W A L S E R
BLOOMINGTON TOYOTA
 4401 American Blvd, Bloomington, Minnesota

3/10/16	PRELIMINARY
4/20/16	CITY SUBMITTAL

SITE PLAN
 Sheet Number

1 LANDSCAPE PLAN
L1 SCALE: 1" = 40'-0"

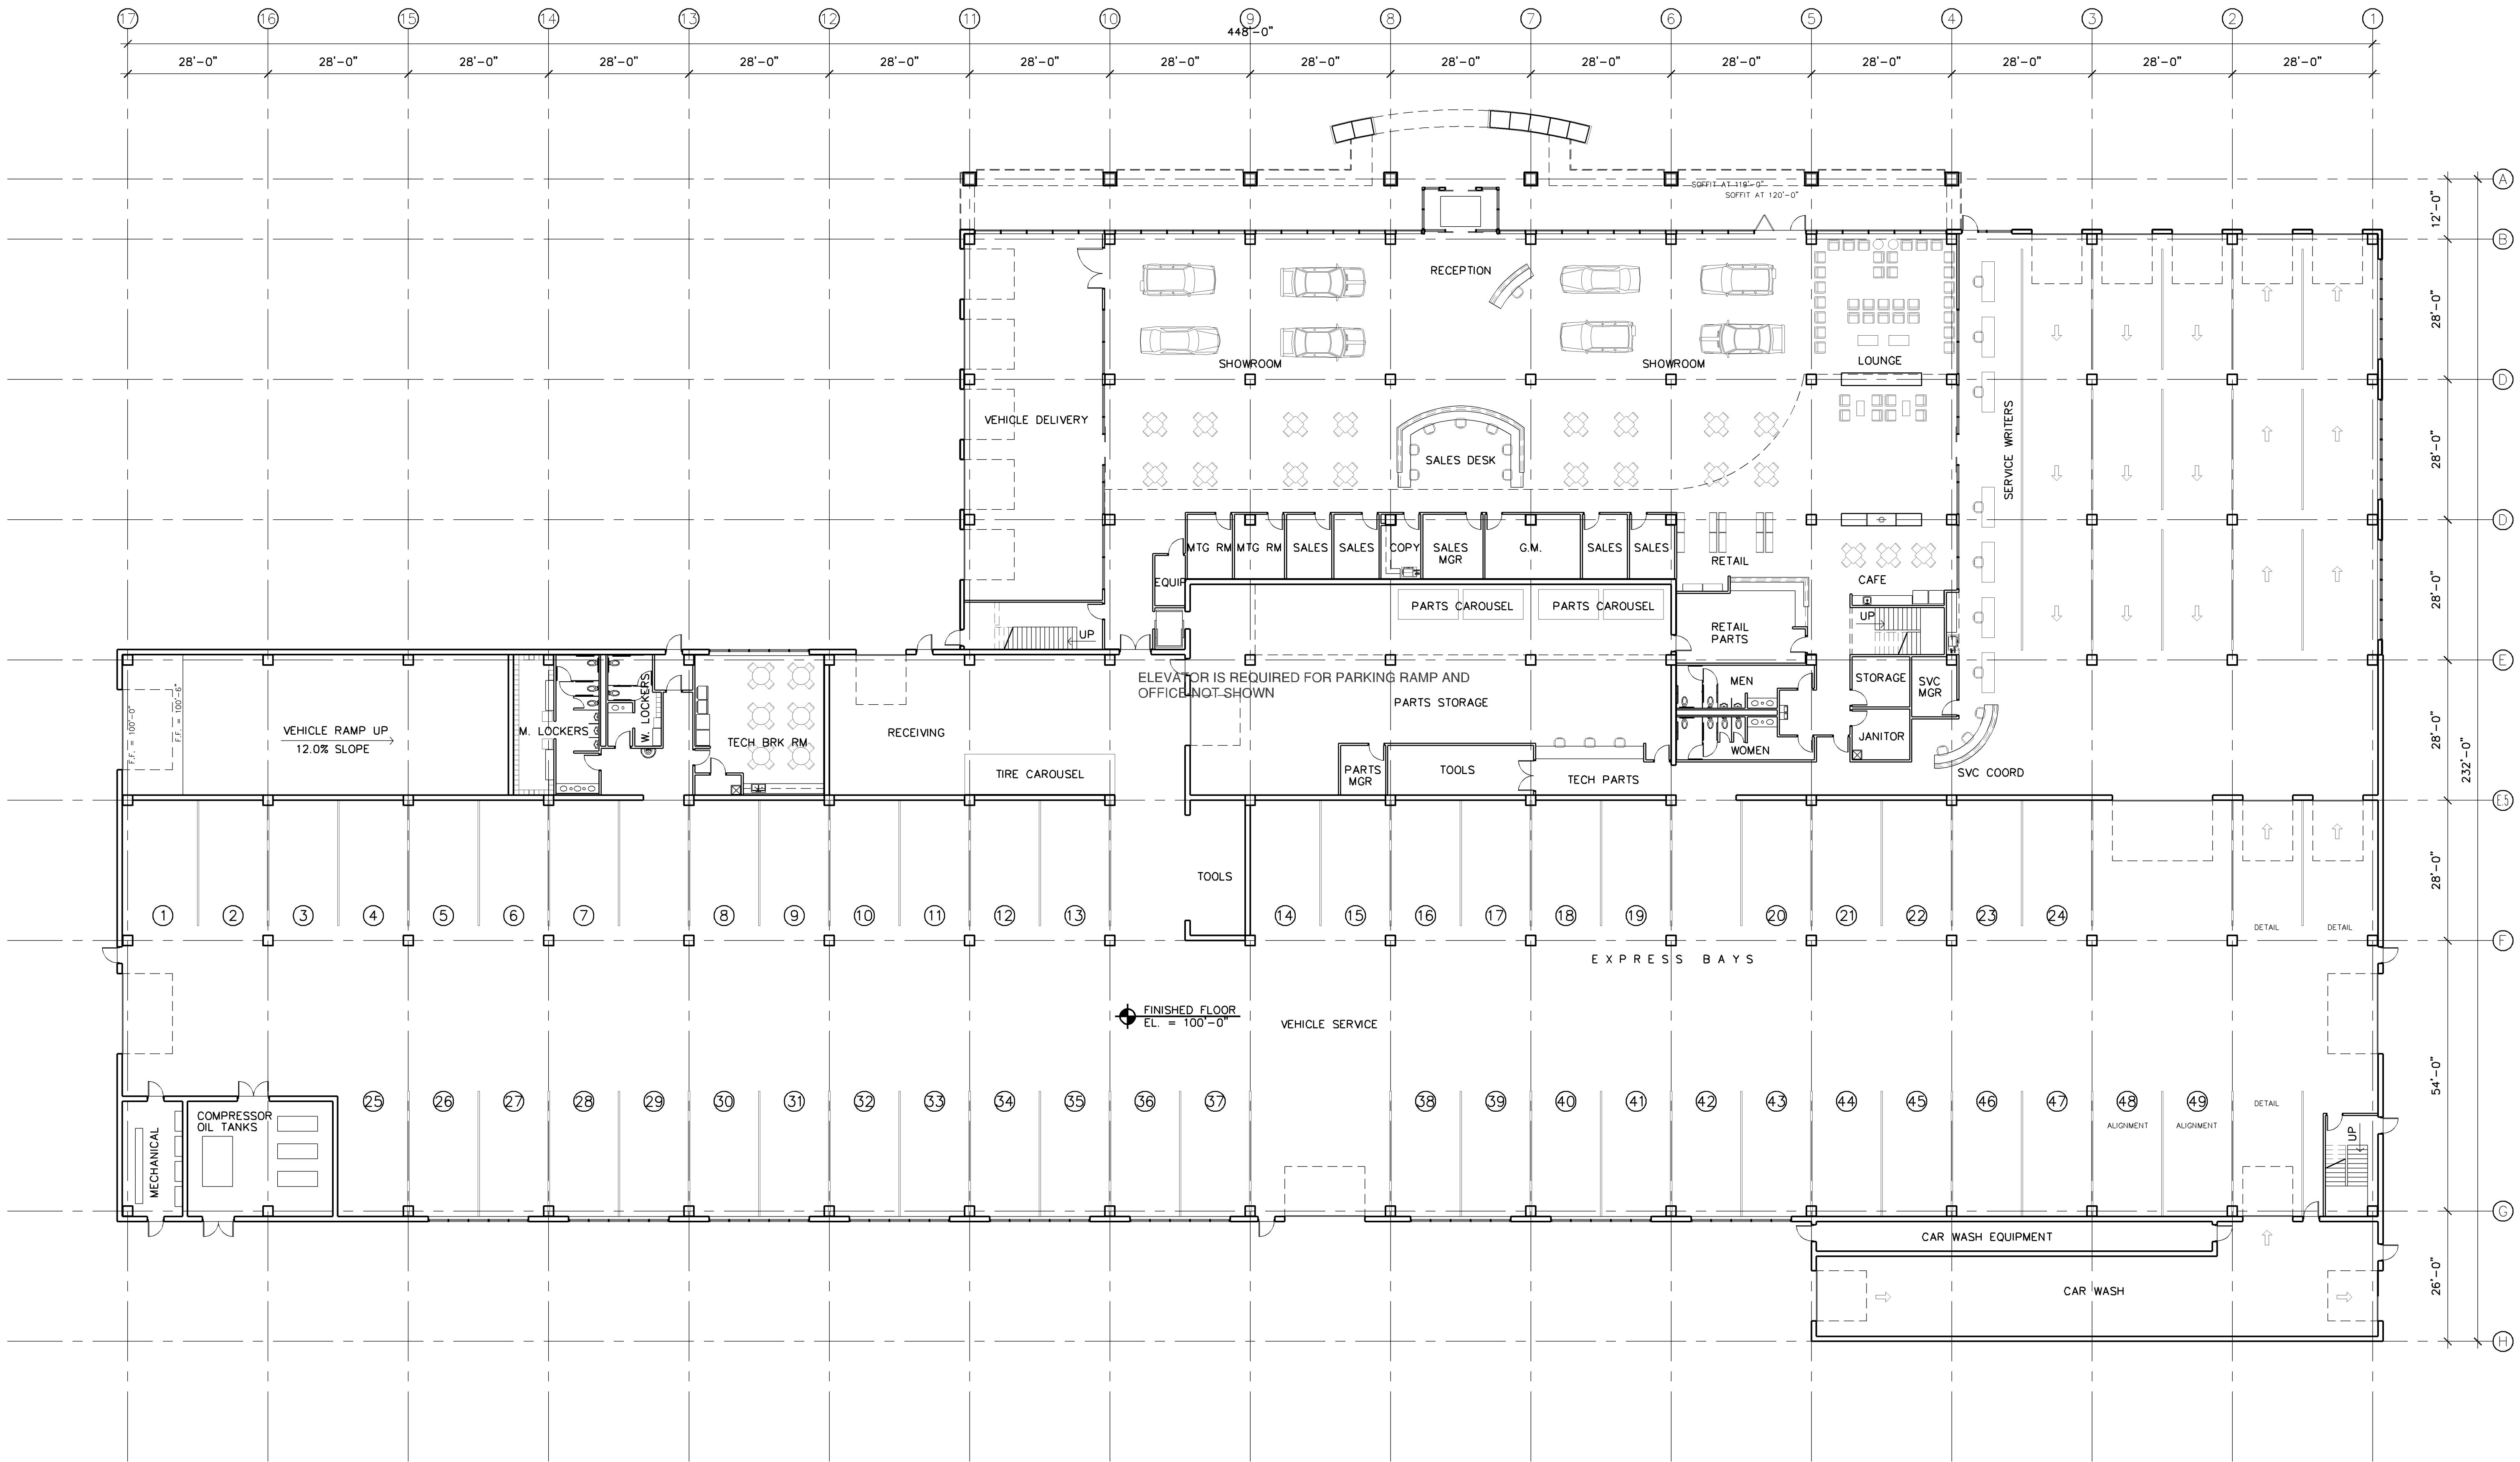
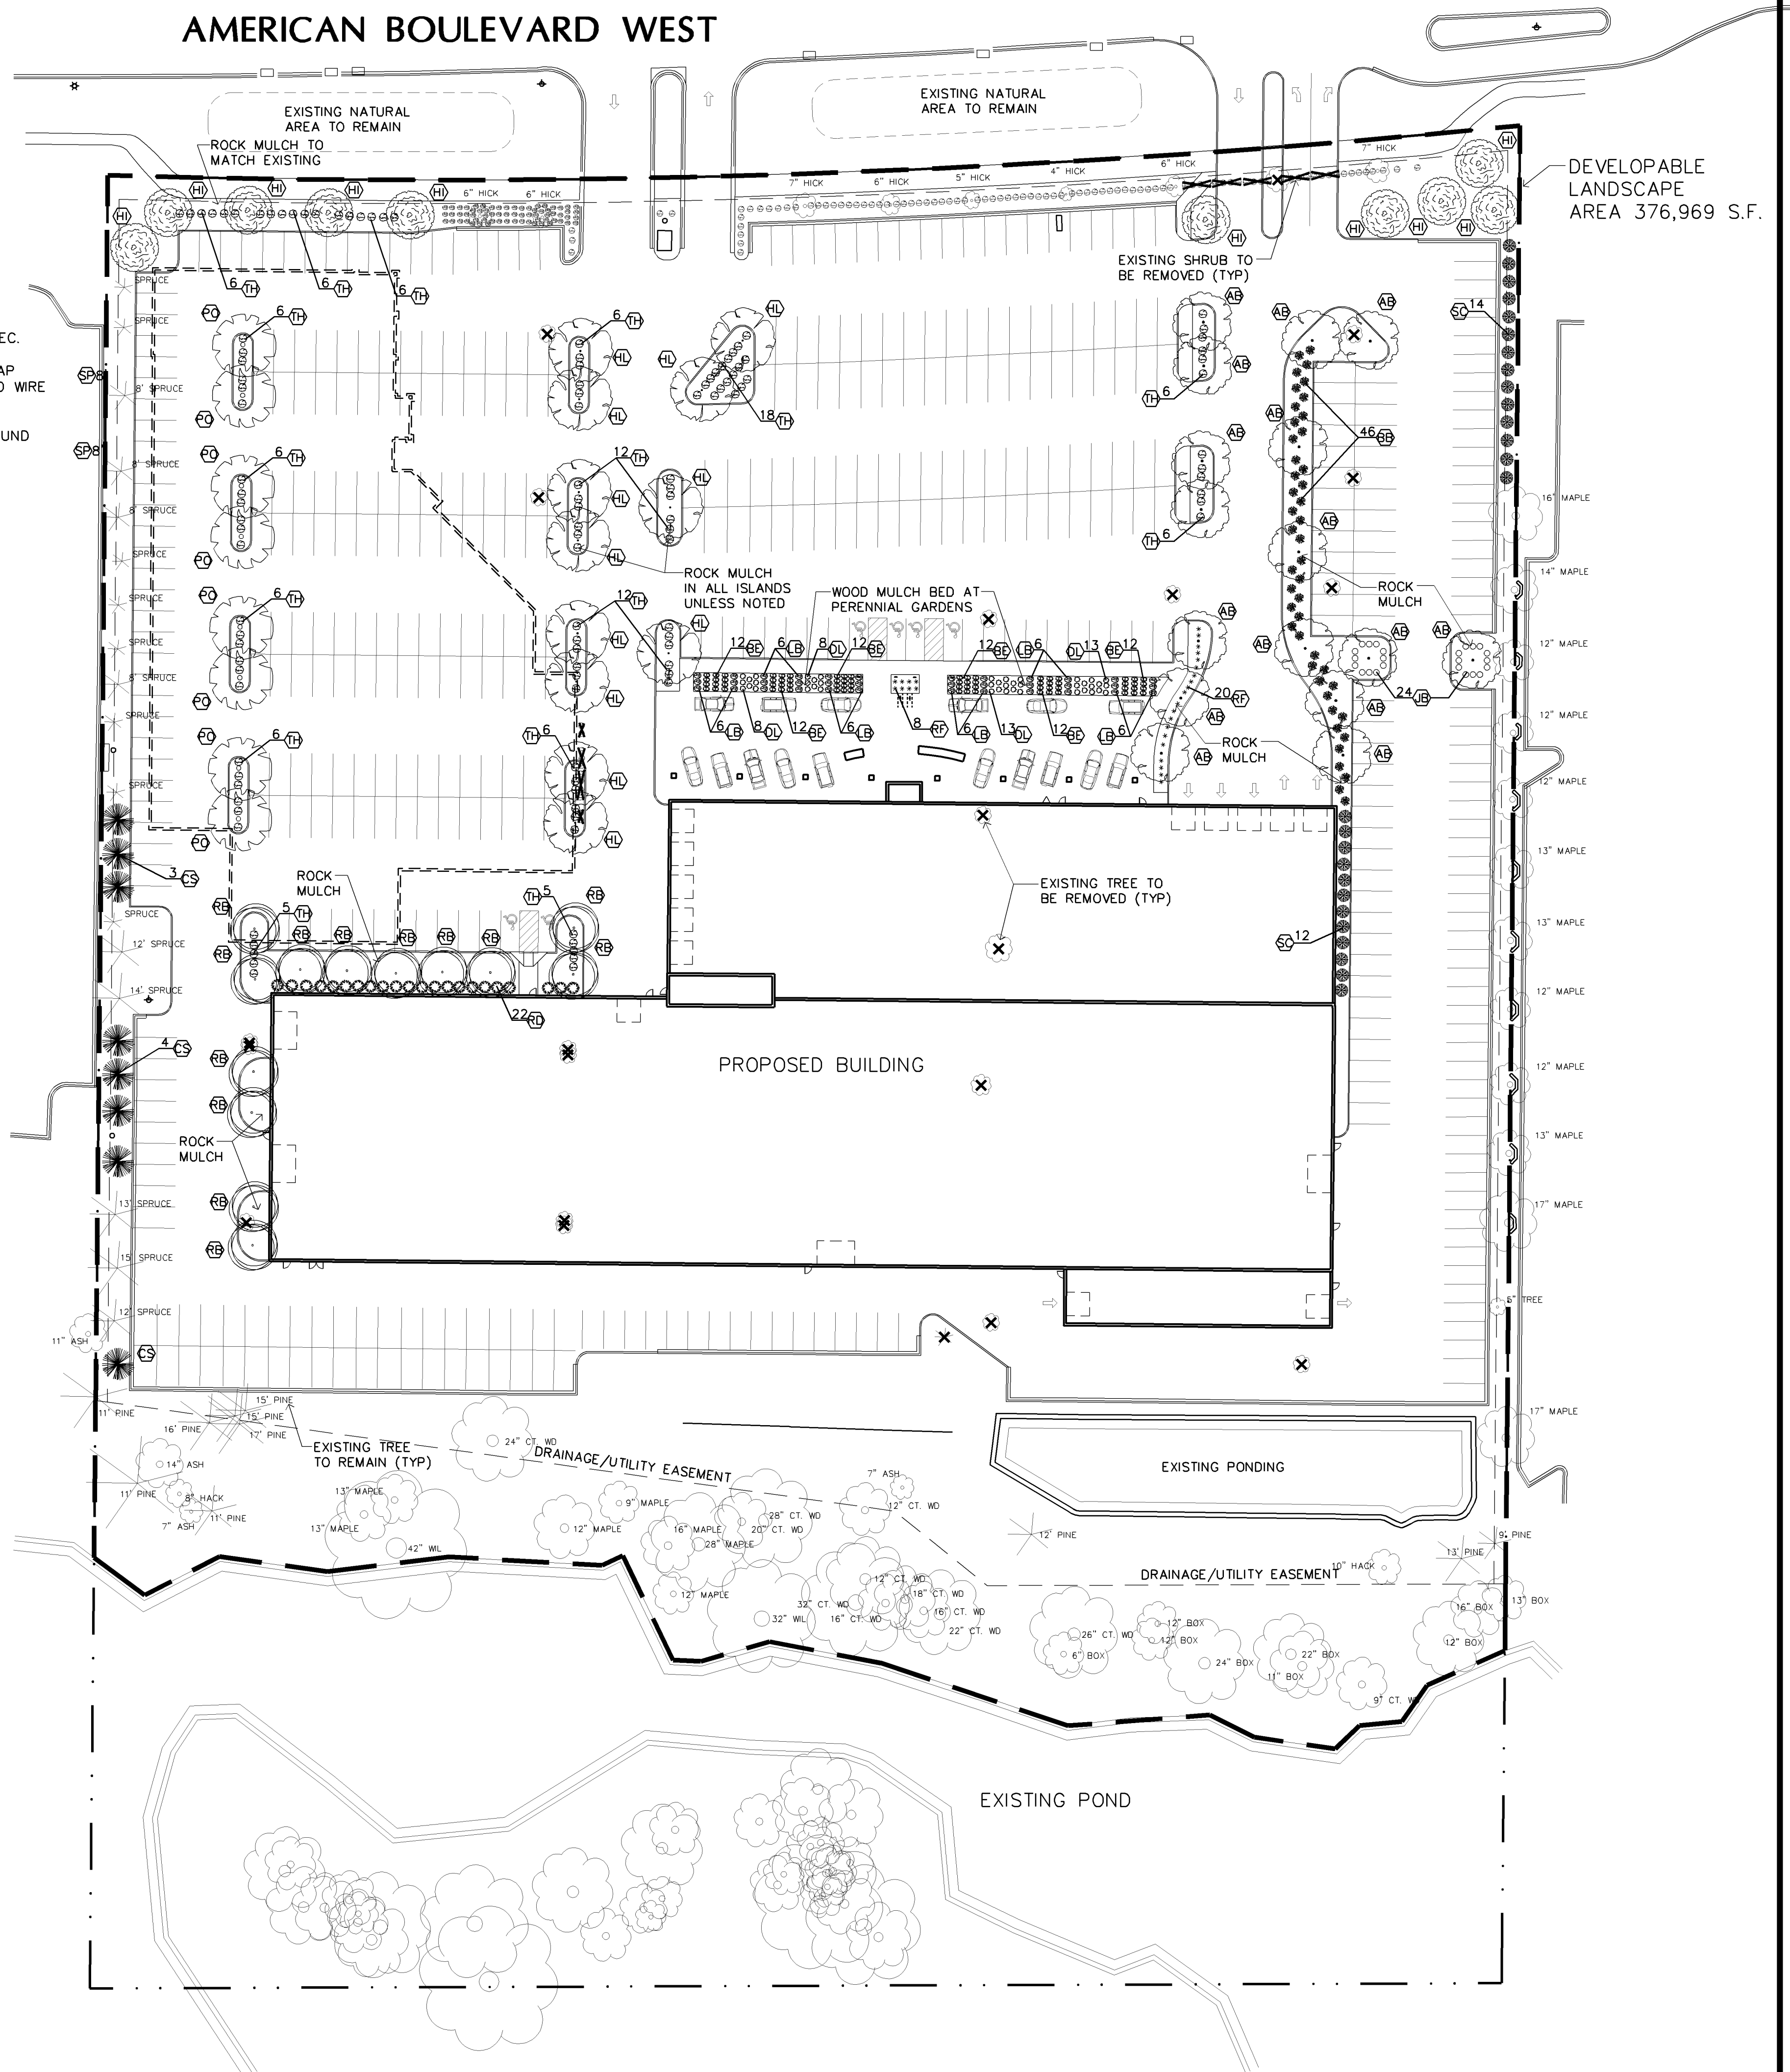
Some of the trees are placed adjacent to proposed lighting. The growth will engulf the lights, long term. Be sure the lighting designer reviews the landscape plan and vice versa.

LIGHTING PROPOSAL LO-132243A

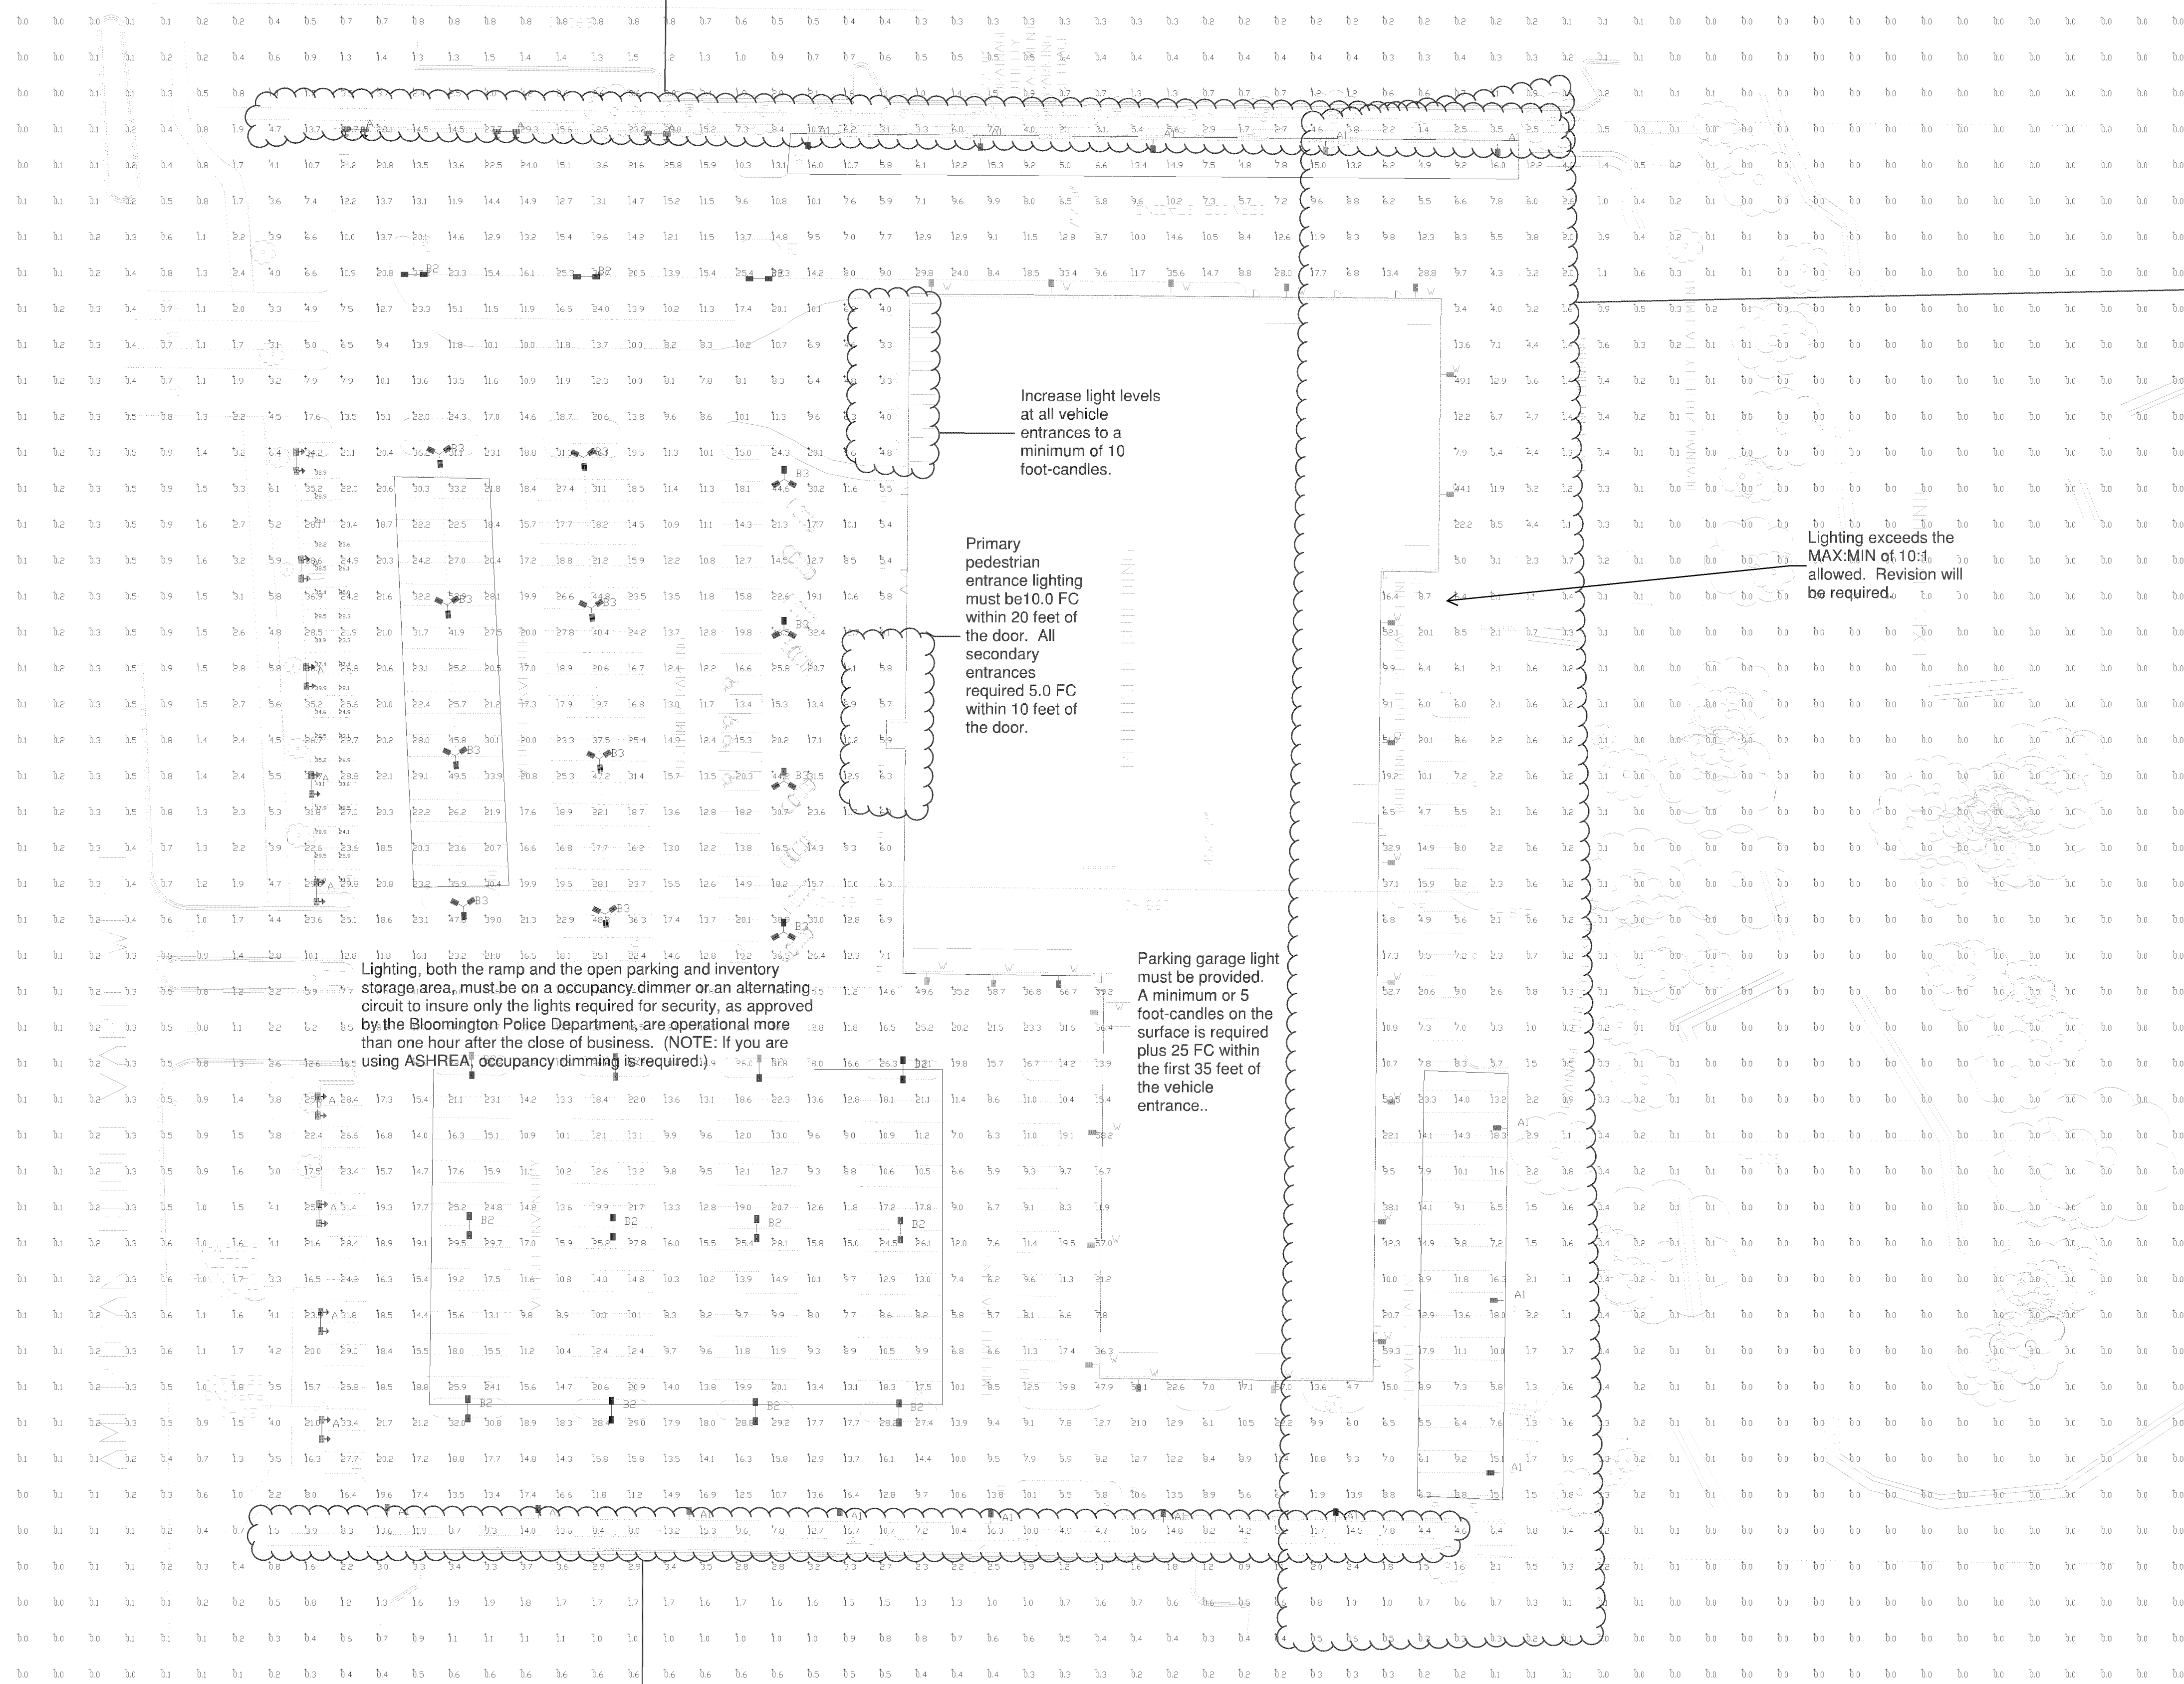
Light levels must not exceed 2.0 foot-candles along the property line. No limit along a public street.

All lighting within 300 feet of the south property line is limited to no more than 30,000 initial lumen's per light source and may not be mounted higher than 28 feet. (Currently, some poles are over 30 feet and over 30,000 lumen's.)

Light levels must not exceed 2.0 foot-candles along the property line. No limit along a public street.

Testing for the LSI Slice will be required. Please provide the LM-79, LM-80 and full IN-SITU reports for review and approval or select an alternative fixture.

All exterior or parking garage lighting plans must be signed by a registered Electrical Engineer or a Lighting Certified (LC) professional certified by the National Council on Qualifications for the Lighting Professions.

Energy use calculations showing compliance with the Minnesota Energy Code, without exemptions is required. All parking lots regulated by this Section are considered public parking lots in the Minnesota State Energy Code.
